**From:** Countryman, Ryan  
**Sent:** Monday, September 19, 2016 2:12 PM  
**To:** Gary Huff (GHuff@karrtuttle.com) (GHuff@karrtuttle.com)  
**Cc:** Kisielius, Laura; McCrary, Mike; Mock, Barb; Otten, Matthew; Rowe, Tom; 'Gary Huff'; 'Douglas A. Luetjen'; 'Steve Ohlenkamp'; 'Jack Molver'; dan.seng@perkinswill.com  
**Subject:** Point Wells  
**Attachments:** Point Wells Preliminary Draft EIS Preliminary Landslide Hazard Comments ....pdf

**Our goals on Tuesday are (1) to find a way to avoid needing an SEIS for Point Wells and (2) to receive a commitment from BSRE to revise the application to comply with code.** The second goal is because number of major revisions to the project design and supporting materials are necessary before we can recommend approval.

Image 1: Landslide Hazard Issues

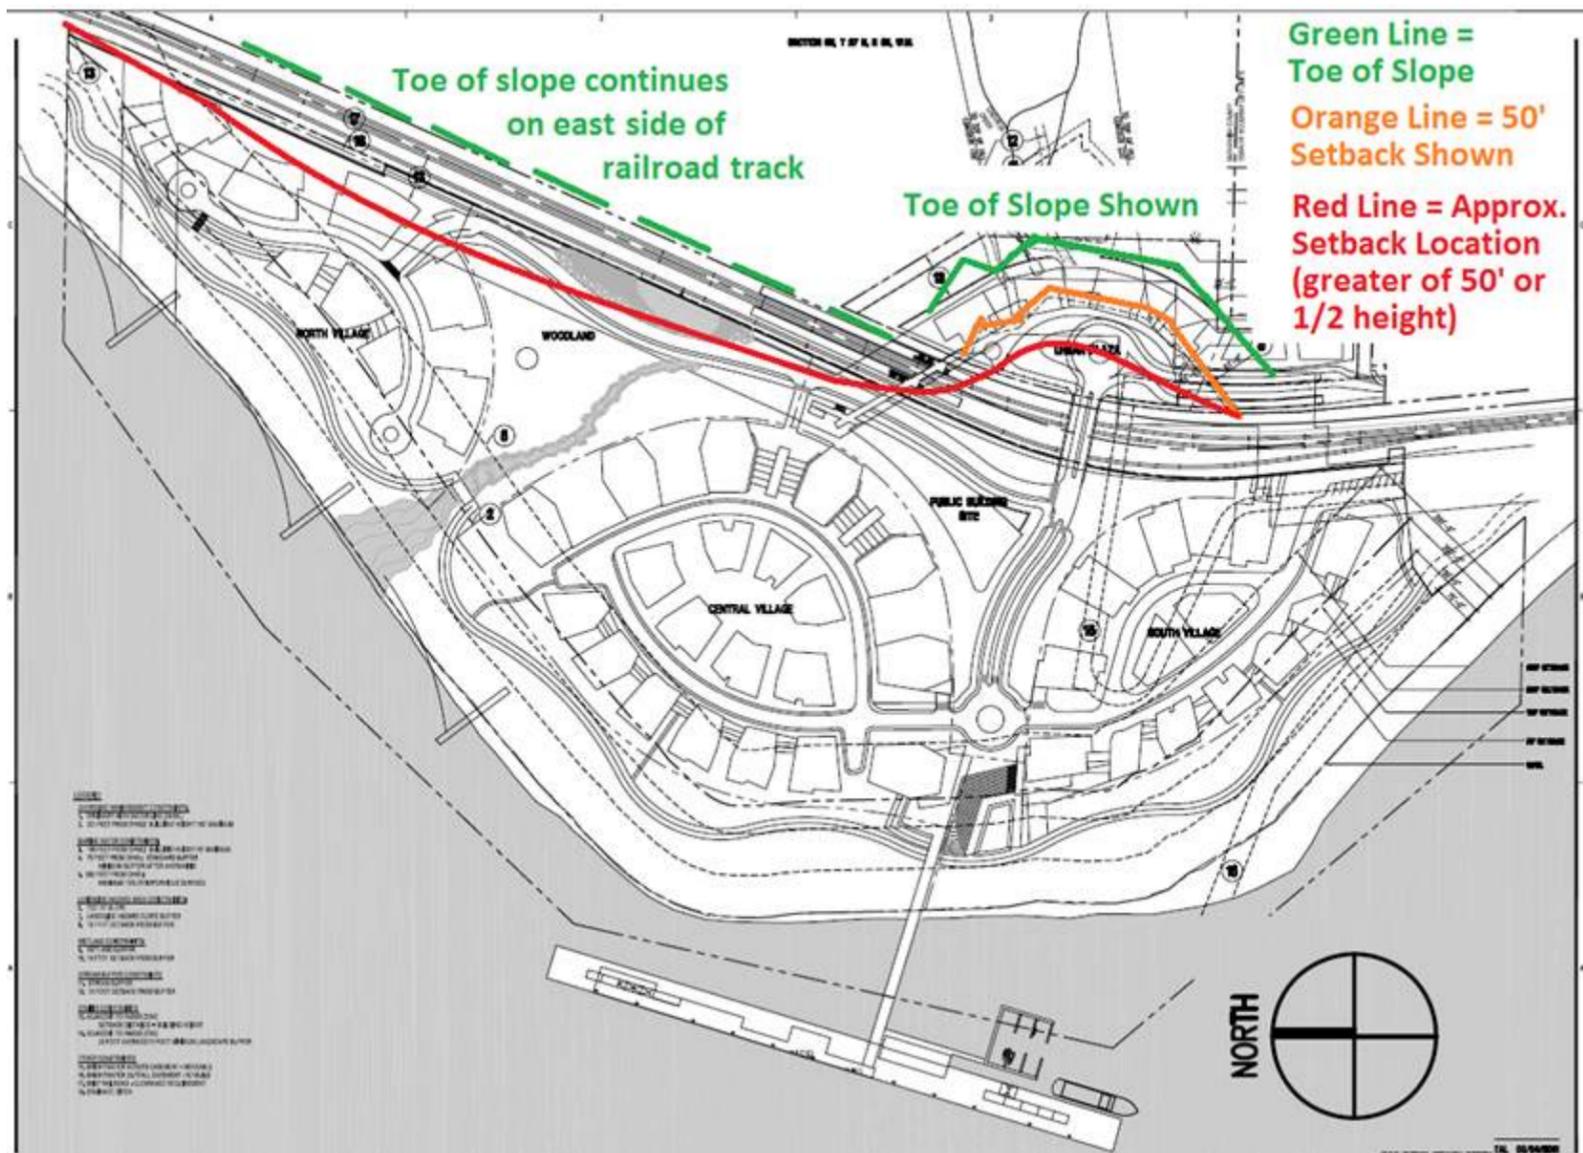
The site plan, geotechnical reports and other documents only discuss landslide hazards in the portion of the site east of the railroad tracks. Image 1 below is adapted from Sheet A-051 and illustrates where a second landslide hazard to the north village is entirely omitted in the application and other materials provided by the applicant. This issue alone would require an SEIS, see attached comments to the preliminary draft EIS. Snohomish County needs this to be part of the EIS review so that we can recommend steps to mitigate landslide risks to buildings and the parking garage in the North Village. Similarly the landslide setbacks shown on the phase east of the tracks do not represent the effective code requirements; thereby rendering insufficient the recommendations that would be based on the setbacks shown.

On page 9 of an [April 12, 2013, Review Completion Letter](#) by my predecessor, Darryl Eastin, it was noted that, the "site development plans do not depict the location and description of all other critical areas regulated pursuant to Chapters 30.62B" [Geologically Hazardous Areas] which is the issue above.

Image 2: Impervious Surface Issues

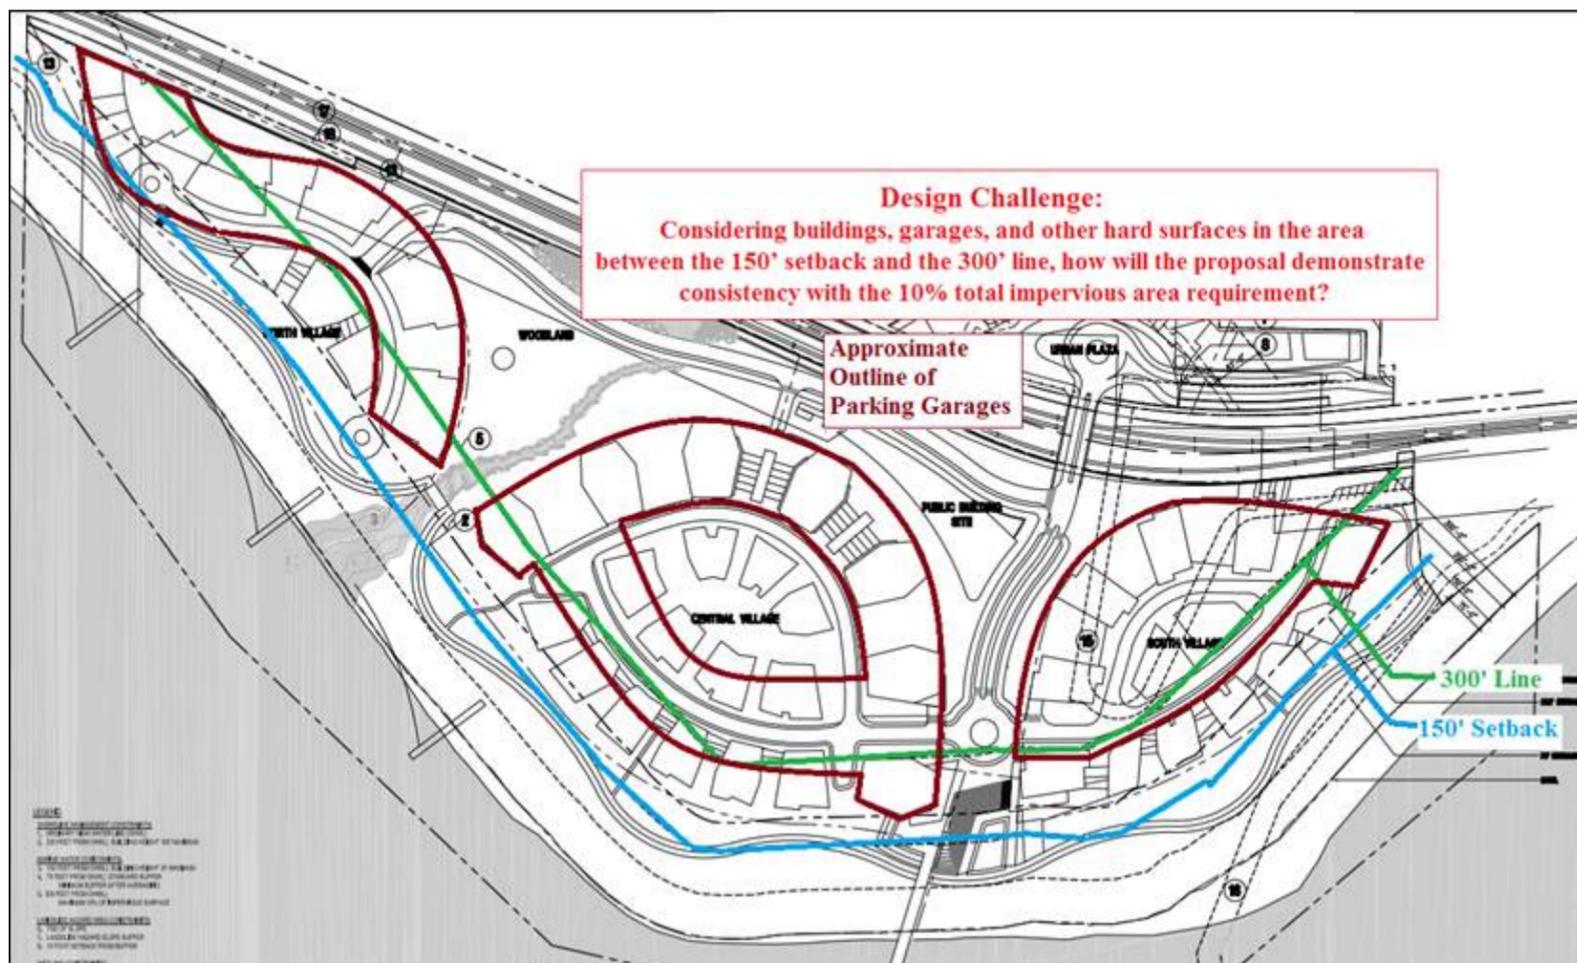
The 2013 letter also asks for "clarification of how the project meets the provisions of SCC 30.62A.320(1)(c) regarding impervious surfaces within buffers" from Puget Sound. We are still waiting for this clarification and have created Image 2 (below) to help illustrate the concern. (Image 2 is also adapted from Sheet A-051). The August

18, 2016, email included at the bottom of this email refers to specific steps that the applicant could take to lessen the design challenge of staying below impervious surface maximums.

Even with the steps that we identified as possibilities for your client to consider, the recommendation in the 2013 letter that “Staff suggests that the applicant make a request for review under the innovative development design provisions of SCC 30.62A.350” stands. Without use by the applicant of the Innovative Development Design [IDD] provisions, we cannot approve the site plan. Even with IDD, it is likely that the amount of impervious surface near Puget Sound will need to be less. Absence of an approved IDD plan means that the DEIS must disclose that the application does not comply with Snohomish County Requirements to protect Wetlands and Fish & Wildlife Habitat Conservation Areas (Chapter 30.62A SCC). We cannot simply recommend conditions of approval on this subject to the Hearing Examiner and expect a favorable decision on the project. Therefore, the applicant must make some changes before the project goes to hearing. These changes may significantly alter the size or design of the project. (Please note that IDD is only part of what it would take to meet code requirements.)
